GPR30/31 Drum Unit

Differences between New & Old Versions of OEM Drum Units Structure

1. Change on main structure:

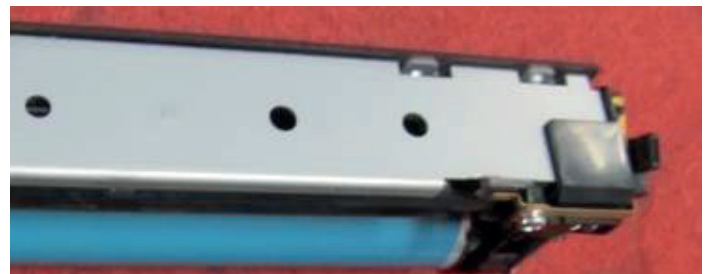
New Version

Old Version

Old version is with metal frame

New version is with plastic frame

- Old version has a metal core – OEM cores – USE 5234 to rebuild.
- New version is plastic USE 5235 to rebuild – OEM also changed to plastic.
